UNITED STATES PATENT AND TRADEMARK OFFICE

APPLICATION NO.	FILING DATE	FIRST NAMED INVENTOR	ATTORNEY DOCKET NO.	CONFIRMATION NO.
10/540,138	06/21/2005	Georg Riescher	4100-357PUS	8881
27799	7590	07/12/2007	EXAMINER	
COHEN, PONTANI, LIEBERMAN & PAVANE			FERGUSON SAMRETH, MARISSA LIANA	
551 FIFTH AVENUE			ART UNIT	PAPER NUMBER
SUITE 1210			2854	
NEW YORK, NY 10176

Office Action Summary	Application No.	Applicant(s)
	10/540,138	RIESCHER ET AL.
	Examiner	Art Unit
	Marissa L. Ferguson-Samreth	2854

DETAILED ACTION

FIG. 4

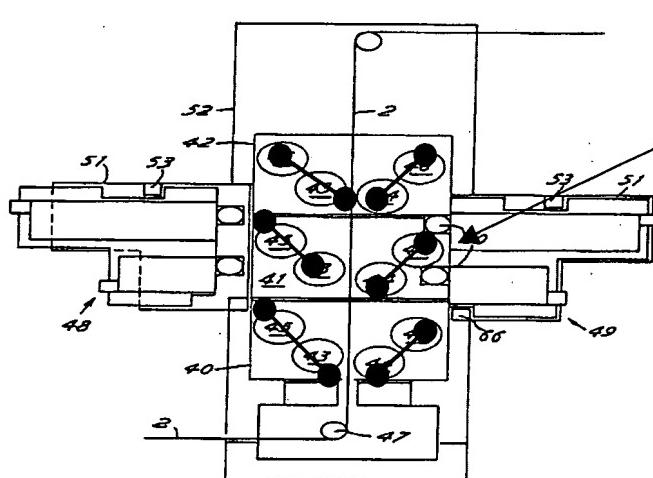
Regarding claim 15, Bowman et al. teaches wherein the printing cylinders are arranged in a line on the crossmember (refer to figure 4 on page 4 of the office action).

FIG. 7

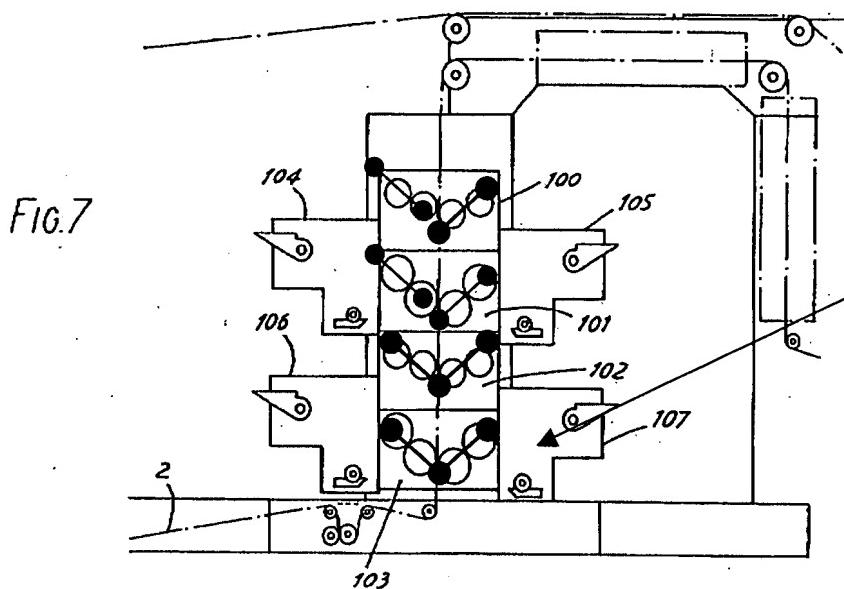
Regarding claim 16, Bowman et al. teaches wherein the printing cylinders are arranged crossed in any direction or at angles to one another (Refer to figure 7 on page 4 of the office action). In this interpretation of Bowman et al., the printing cylinders are considered to be 43-46 that form the angles.
